Access Compliance Report Public Rights-of-Way (Curb Ramps)

Main Street: CHESNEY_DR Cross Street: WEMBLEY_RD Location: SW

ADA ID: RPAT211201085905 Ramp Type: Type 1 - Perpendicular Diagonal Initial Pass/Fail: Fail Overall Compliance: No Severity Score: 16

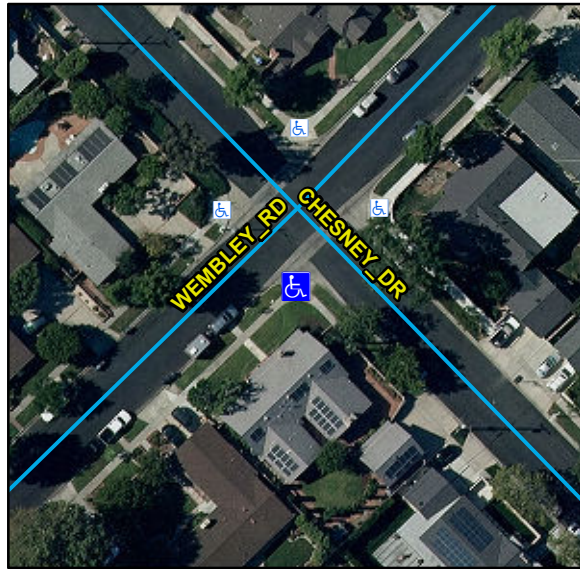
R204.3, R304.2.2, STD 1115

Remove & Replace Curb Ramp With Two New Directional Ramps or Equivalent.
